ECE/TRANS/WP.29/GRRF/2008/2
26 November 2007

ALIGNEMENT OF REGULATIONS Nos. 13 AND 13-H
(Braking)

Brake assist systems

Proposal for amendments to Regulation No. 13-H

Figure 1: Pedal force characteristic needed in order to achieve maximum deceleration with category 'A' BAS

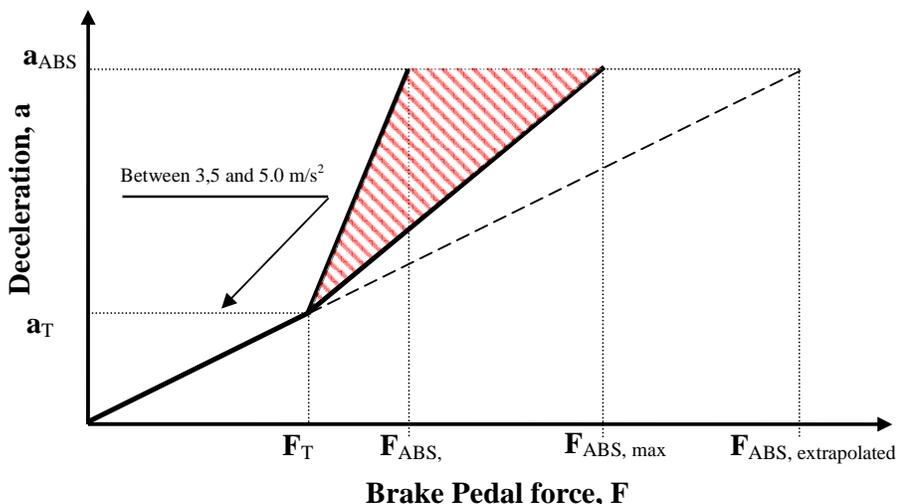
3.2.3. F_T and a_T are threshold force and threshold deceleration as shown in Figure 1. The values of F_T and a_T shall be supplied to the Technical Service at the time of submission of the type-approval application. The value of a_T shall be between 3.5 m/s² and 5.0 m/s².

3.2.4. A straight line is drawn from the origin through the point F_T, a_T (as shown in Figure 1). The value of brake pedal force 'F', at the point of intersection between this line and a horizontal line defined by $a=a_{ABS}$, is defined as $F_{ABS, extrapolated}$:

Figure 2: Test 2 of a category 'B' BAS system

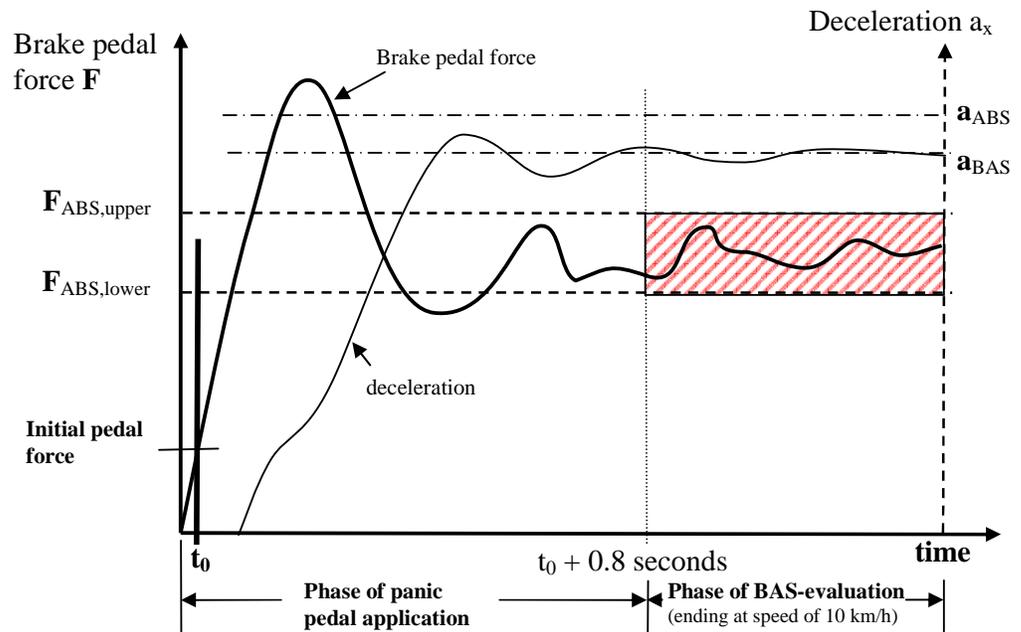
The vehicle shall be driven in a straight line at the test speed specified in paragraph 2.4. above. The driver shall apply the brake pedal quickly according to Figure 2, simulating emergency braking so that BAS is activated and ABS is fully cycling.

After $t = t_0 + 0.8$ s and until the vehicle has slowed down to a speed of 10 km/h the brake pedal force shall be maintained in a corridor between $F_{ABS, upper}$ and $F_{ABS, lower}$. Where $F_{ABS, upper}$ is $0.7 F_{ABS}$ and $F_{ABS, lower}$ is $0.5 F_{ABS}$.

Figure 3: Deceleration corridor for determination of F_{ABS} and a_{ABS}

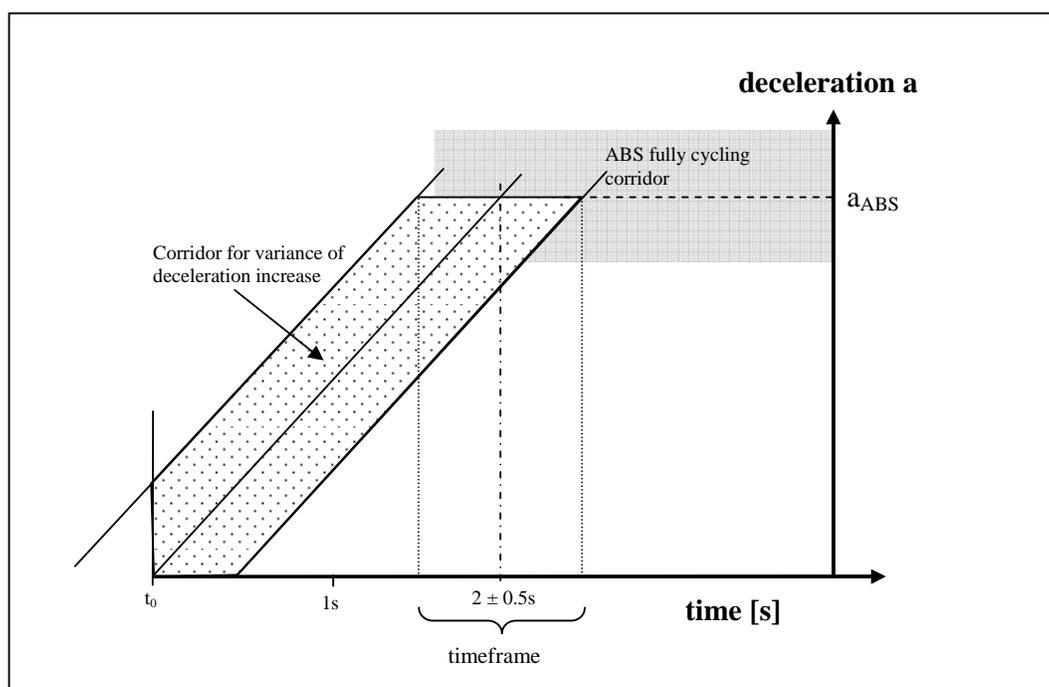
- 1.2. The brake pedal shall be applied slowly (without activating the Brake Assist System) providing a constant increase of deceleration until ABS is fully cycling (Figure 3).

- 1.3. The full deceleration must be reached within the timeframe of 2.0 ± 0.5 s. The deceleration curve, recorded against time, must be within a corridor of ± 0.5 s around the centre line of the deceleration curve corridor. The example in Figure 3 has its origin at the time t_0 crossing the a_{ABS} line at 2 seconds. Once full deceleration has been achieved the pedal travel [S_p] shall not be decreased for at least 1 s. The time of full activation of the ABS system is defined as the time when pedal force F_{ABS} is achieved. The measurement shall be within the corridor for variance of deceleration increase (see Figure 3).

Figure 4: Determination of the value of F_{ABS}

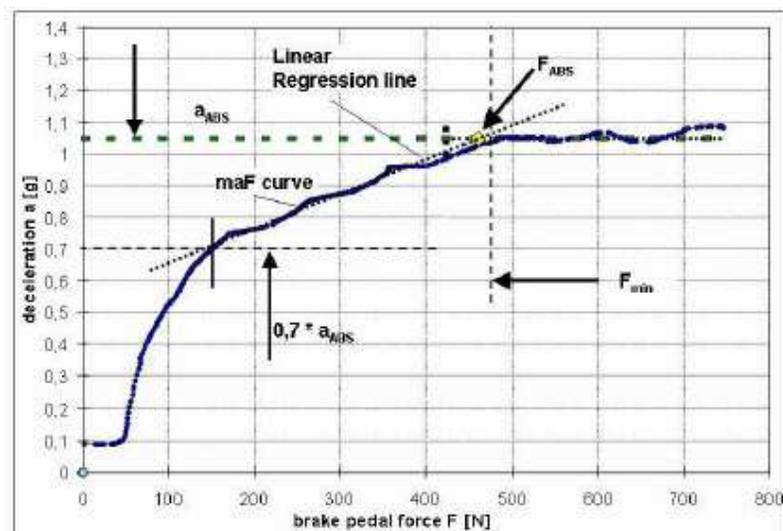
- 1.8. The five individual 'deceleration versus brake pedal force' curves are averaged by calculating the mean deceleration of the five individual 'deceleration vs. brake pedal force' curves at increments of 1 N pedal force. The result is the mean deceleration versus brake pedal force curve (Figure 4), which will be referred to as the "maF curve" in this appendix.

- 1.10. Using linear regression, a straight line is drawn through all maF curve values below the pedal force F_{min} and above the line representing 70 per cent of ABS deceleration ($0.7 * a_{ABS}$). The value of the brake pedal force ' F ' at the point of intersection between this line and the horizontal line where $a = a_{ABS}$ is defined as F_{ABS} .
